Cabinet Member for City Services

30 November 2022

Objections to Proposed 20mph Zone – Cannon Park Road

Appendix A – Plan of Cannon Park Area 20mph Zone

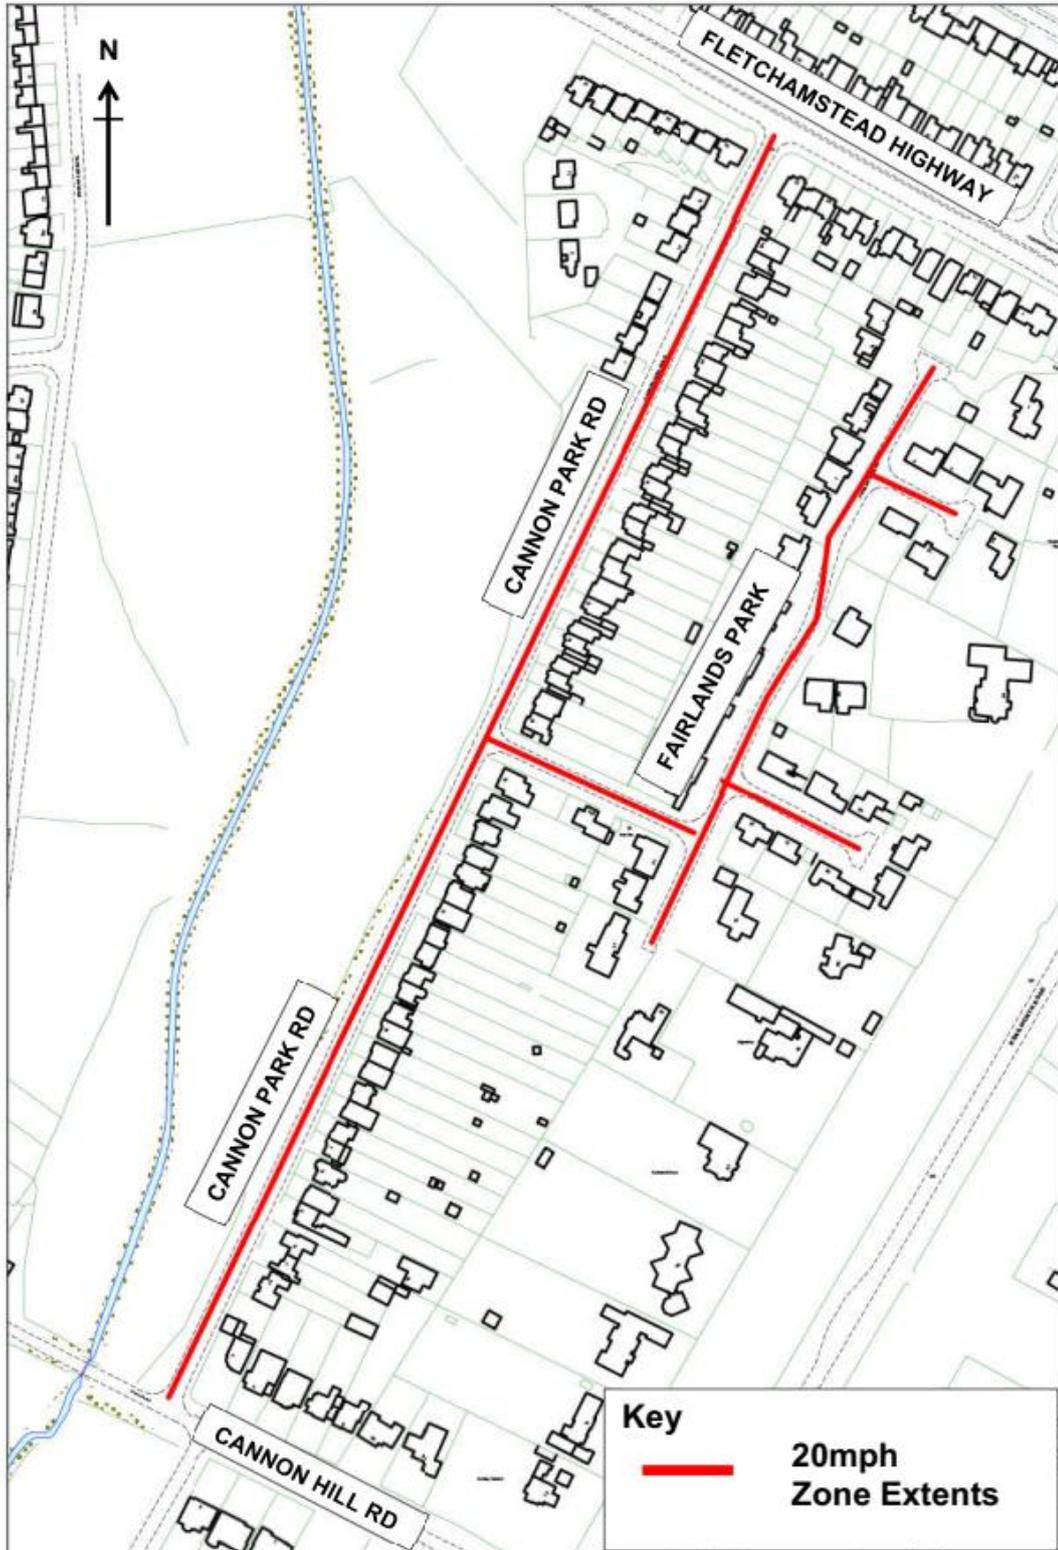
Objection Summary (common theme from objectors)	<p>I think the 20 mile per hour speed limit and rondels are not necessary and completely over the top in both Cannon Park Road and Fairlands Park. Having lived in Fairlands Park for 26 years I have never seen anybody speed.</p> <p>I think the council would have better things to spend their money than this project.</p>

Response to Objection	<p>There is potential for Cannon Park Road to be used as a cut-through and therefore the reduction in the speed limit to 20mph is justified from a road safety perspective.</p>
Objection Summary	<p>I write concerning the proposed introduction of a 20mph speed limit in Cannon Park Road following the installation of road safety schemes in the Cannon Hill Road area. We believe that speed limiting measures such as roundels should only be installed when there are likely to be real benefits: roundels and cushions cause increases in pollution and noise due to the traffic slowing down and then accelerating after each one and this should be avoided if possible. We have watched to see if there has been any increase in traffic in Cannon Park Road since the 20mph zone was introduced in the Cannon Hill Road area and there has been no noticeable change. To our knowledge there has never been an accident in the road (we have lived here for over 50 years) and we therefore feel that the proposed scheme in Cannon Park Road is undesirable and unnecessary and a waste of money.</p>

Support	<p>There are many cars currently travelling at far higher speeds along Cannon Park Road. However, I am afraid that simply installing roundels along the road will not resolve this issue. People who clearly break the law re 30mph when they are doing 50mph will simply not slow down to 20mph because of a roundel. What is clearly required is the installation of a pair of speed humps at appropriate positions along Cannon Park Road. It is acknowledged by the proposal that there is an issue of traffic speeding along Cannon Park Road, and the only realistic way to enforce this is to install such speed humps. The issue has been exacerbated by drivers using the road as a cut through to the A45 from Kenilworth to avoid the traffic lights and the raised humps and cushions on Cannon Hill Road. The cost of installing two sets of speed humps will not be great and would provide an effective conclusion to the wider area scheme introduced earlier this year. Fairlands Park is clearly not an issue given the short sections of road involved and because it is a cul-de-sac.</p> <p>On a separate but related matter, there is a remaining 30mph roundel at the Kenilworth Road end of Cannon Hill Road together with the 30mph signs. Does this mean that the 20mph zone starts just beyond the junction with Cannon Park Road where there is a 20mph roundel? If this is the case, I would suggest it seems somewhat confusing to drivers given that there are no equivalent 20mph signs to notify the start of the zone, other than the roundel on the road. I would be interested to know what is the actual situation.</p>

Response to Objection	<p>The proposed 20mph speed limit zone is not proposing any physical traffic calming measures. A 20mph speed limit zone has signage and carriageway markings to reinforce the speed limit and to remind drivers to drive carefully. The council will monitor the situation to ensure it is effective as optimising speed compliance.</p>
